**LEVY NUCLEAR PLANT, UNITS 1 AND 2
DOCKET NOS. 52-029 AND 52-030
RESPONSE TO REQUEST FOR ADDITIONAL INFORMATION LETTER NO. 095 RELATED TO
PROBABLE MAXIMUM SURGE AND SEICHE FLOODING**

**Levy Nuclear Plant Units 1 and 2
Response to NRC Request for Additional Information Letter No. 095 Related to
SRP Section 2.4.5 for the Combined License Application, dated October 4, 2010**

NRC RAI NUMBER: 02.04.05-10

Figure RAI 2.4.5-10-11

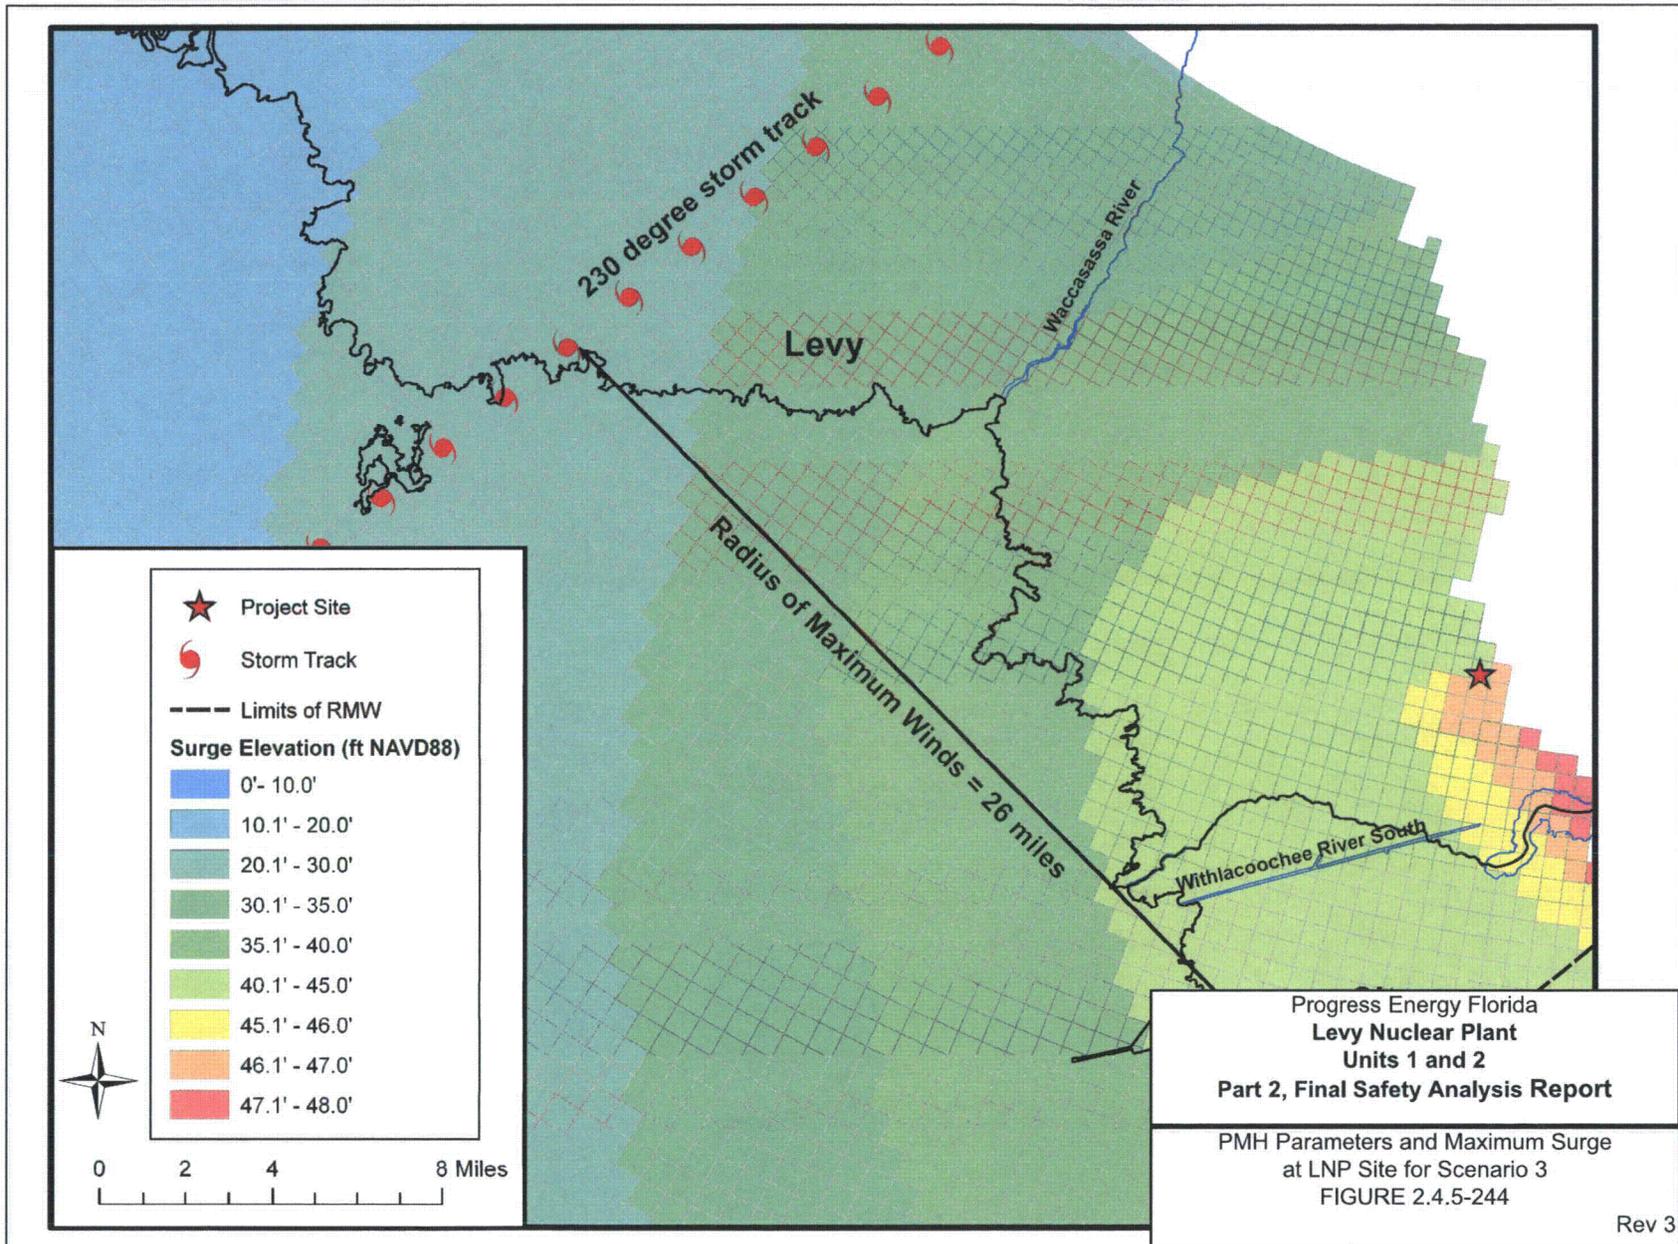
Figures RAI 2.4.5-10-6 through RAI 2.4.5-10-11 provide the SLOSH display screenshots and maps displaying the surge at the time of the peak surge for the site, for Scenarios 1, 2, and 3, shown in Table 7.

Figure RAI 2.4.5-10-12

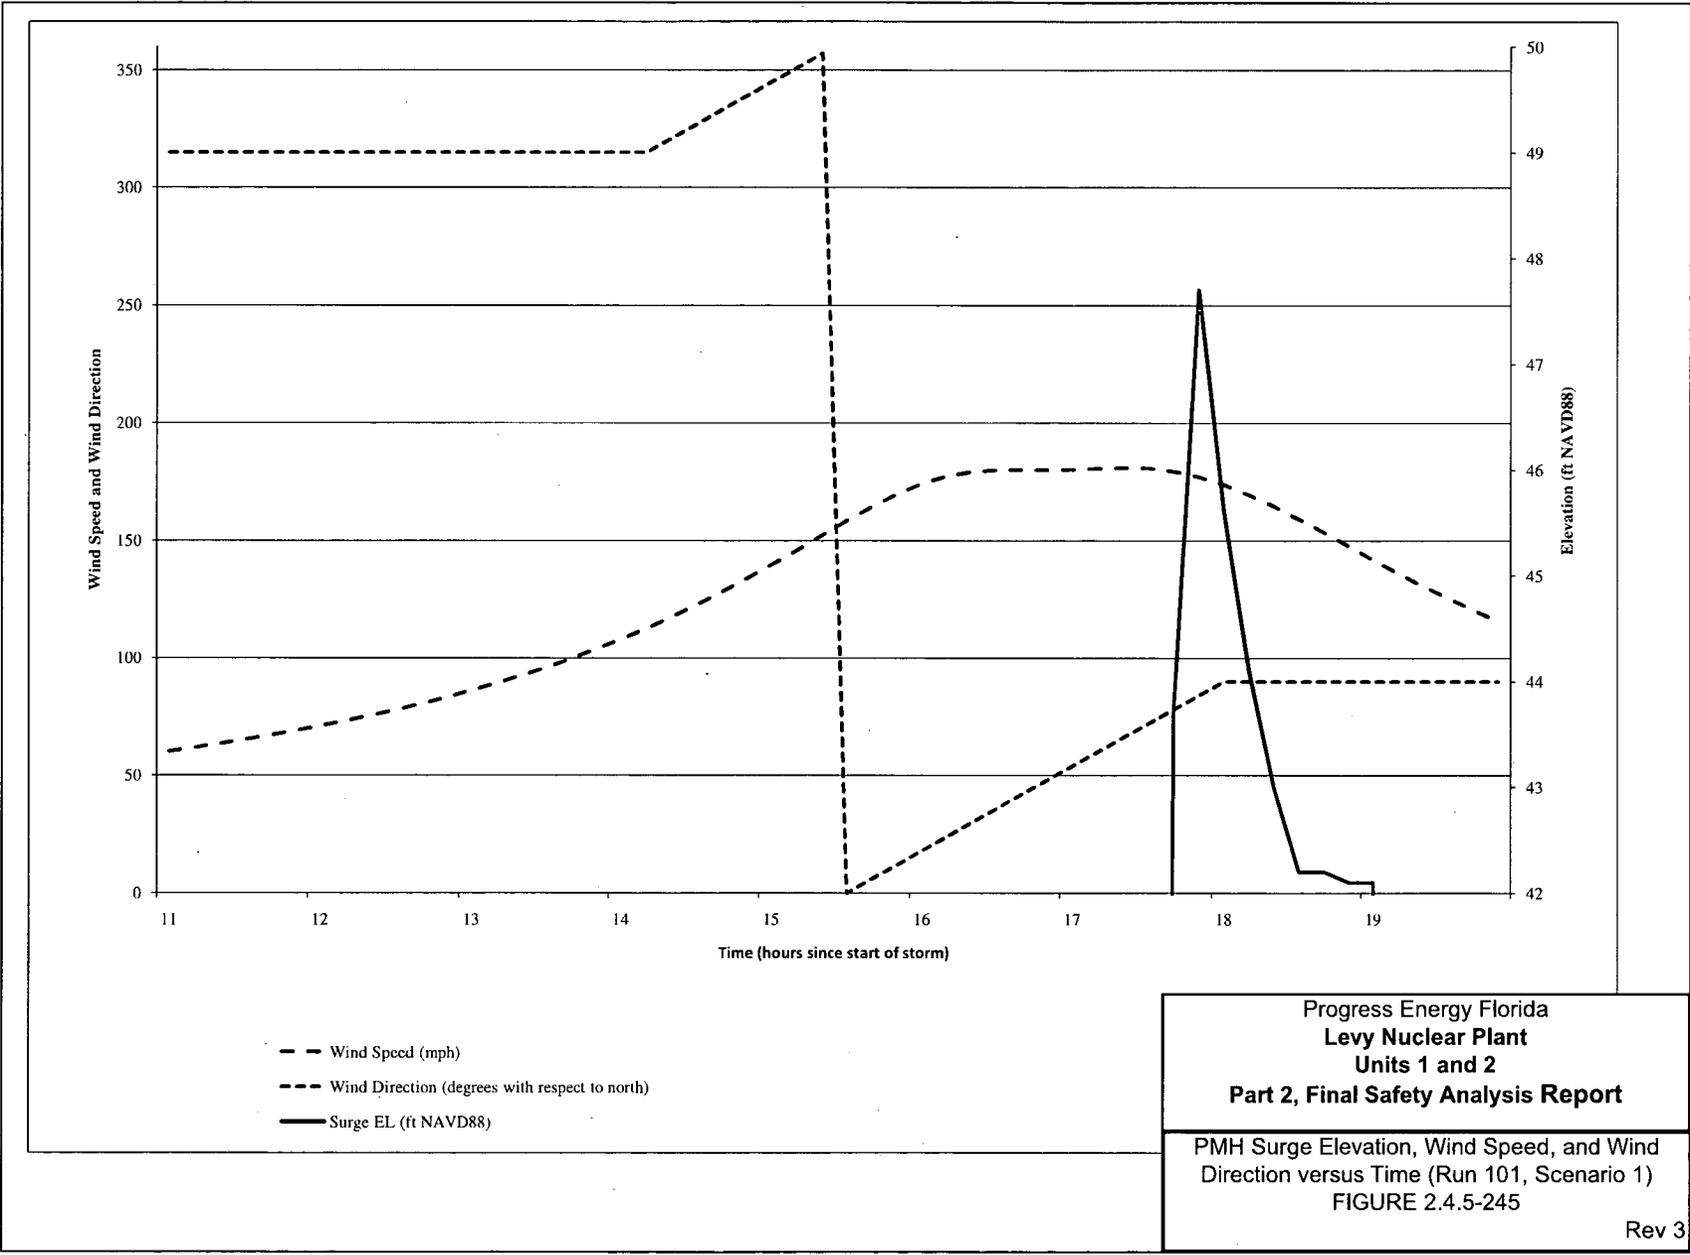
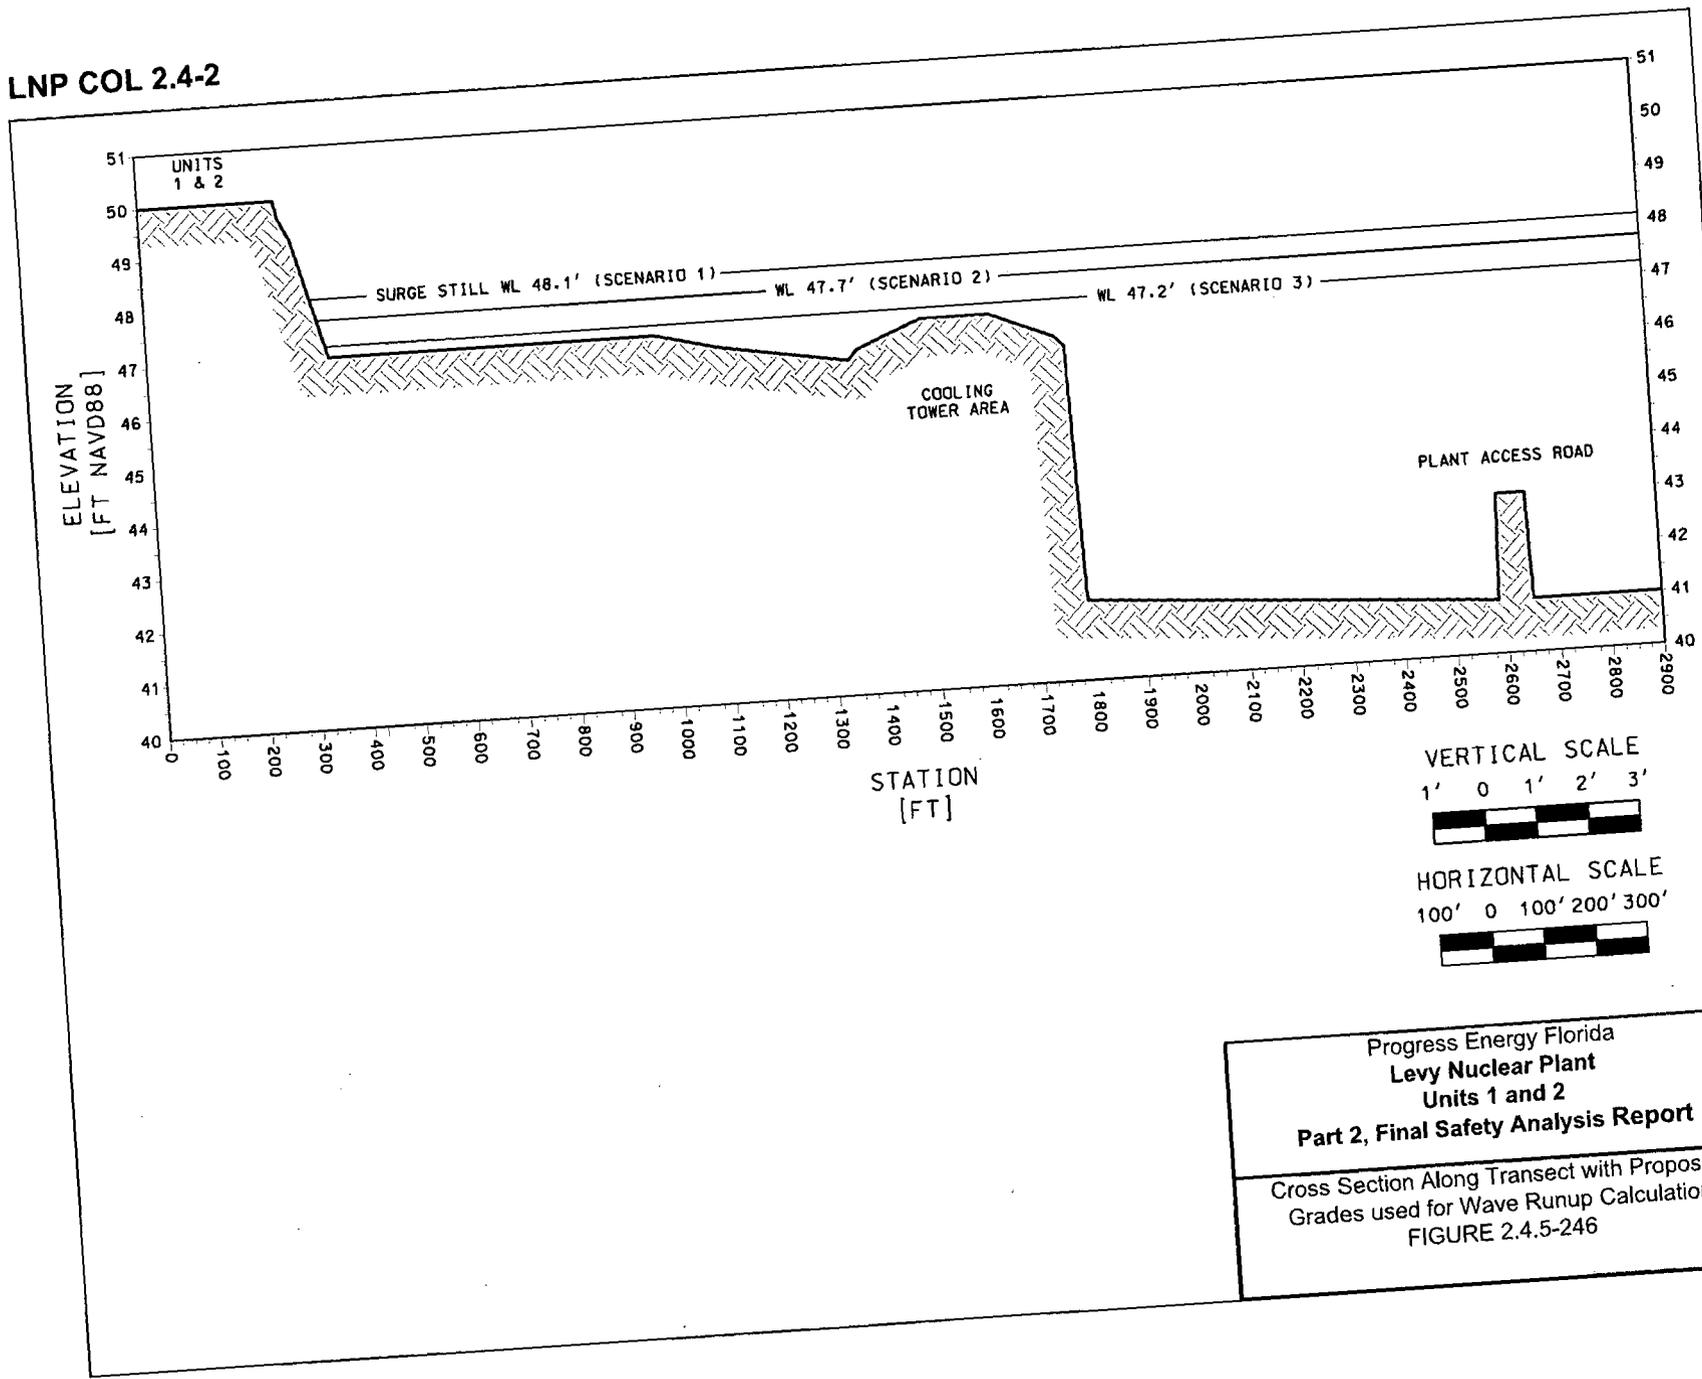
For all scenarios, the time variations of surge elevation, wind speed, and wind direction follow the pattern shown in Figure RAI 2.4.5-10-12. The maximum surge condition of 47.7 feet for scenario 1, Run 101, is depicted in Figure RAI 2.4.5-10-12. The cells that include the site have an average elevation of 42 feet; the cell remains dry until the surge elevation exceeds 42 feet. The peak surge elevation occurs at the site for a narrow time frame, one time step, of ten minutes. Water enters the cell at one time step (10 minutes) prior to the peak. Peak winds of 180 mph are felt for about one hour with the peak surge occurring 20 minutes after the winds have begun to decline below 180 mph. Wind direction is northwesterly (onshore) as the hurricane makes landfall, clocking around to an easterly direction (offshore) over a five hour period as the hurricane passes, consistent with the typical dynamics of hurricanes.
